League of Illinois Bicyclists

Ms. Kathy Ames
Illinois Department of Transportation
2300 S. Dirksen Pkwy
Springfield, IL 62764
RE: BDE Manual bike/ped policy review

IDOT BDE Manual bike/ped excerpts and comments

League of Illinois Bicyclists, June 2006

MINIMUM CROSS SECTIONS FOR SHARED URBAN ROADWAYS
(Unmarked Bicycle Lanes)
Figure 17-2C

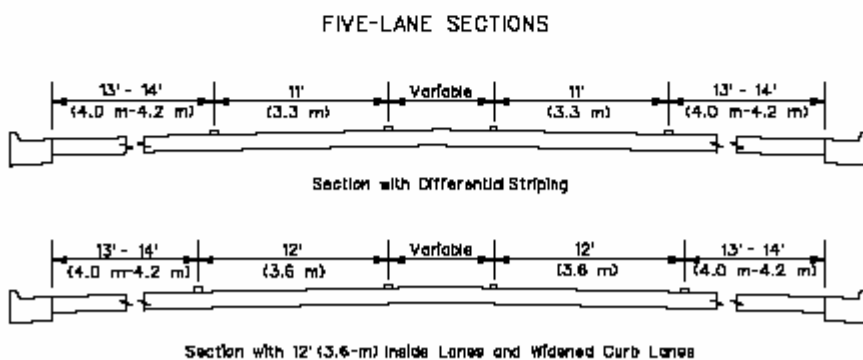
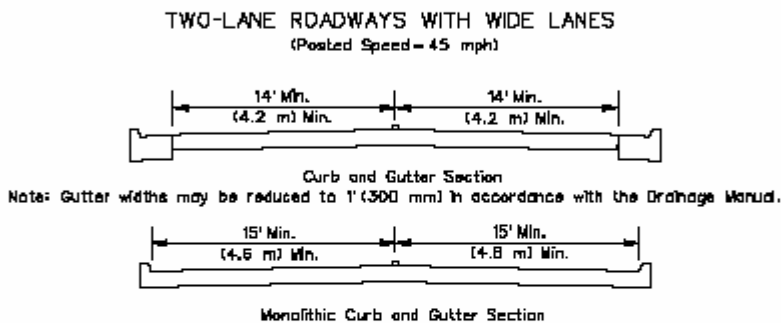
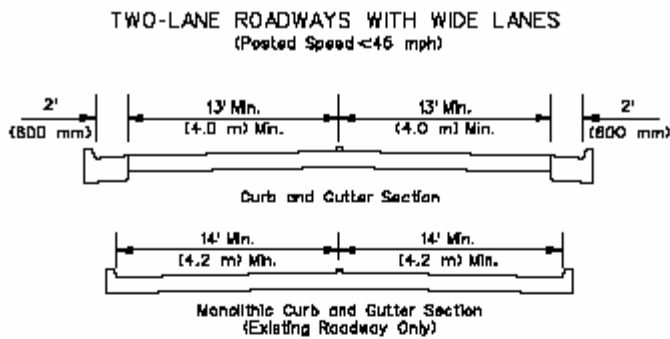
percentage of truck traffic increases, the width should increase according to the criteria presented in Figure 17-2C. [From our observation, it seems that 13' is the norm on 45mph multi-lane suburban roads. In a couple instances, this was increased to 14' after a detailed call for better accommodation.] Measure the width of the lane from the lane stripe to the joint between the pavement and the gutter. If no joint exists, as with monolithic pavement, take the measurement to the face of the curb. Bicycles, because of their narrow tires, cannot be expected to be ridden on or near a longitudinal pavement joint because of the potential for catching the wheel in the joint and throwing a rider into traffic.

Figure 17-2D

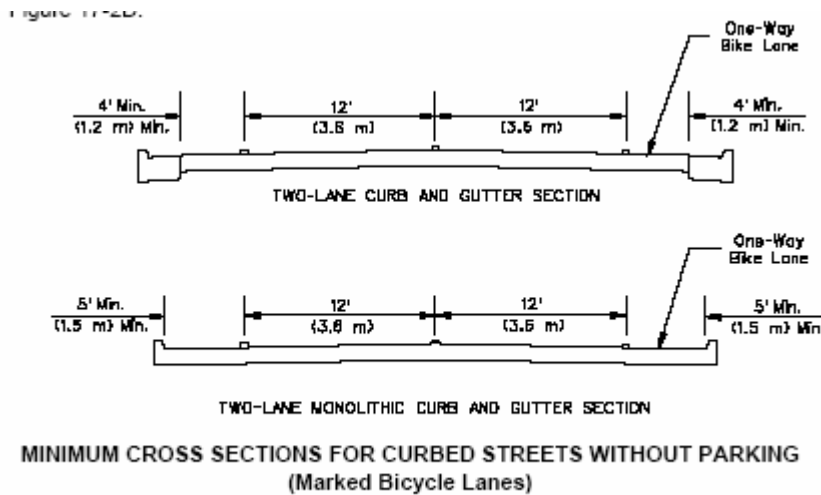
[The “may be considered appropriate” phrase seems too loose for interpretation for a topic that many have not received training on. Perhaps stating that the provision of bike lanes “is appropriate” more closely matches the intent and the wording in the AASHTO bike guide and the FHWA report.]
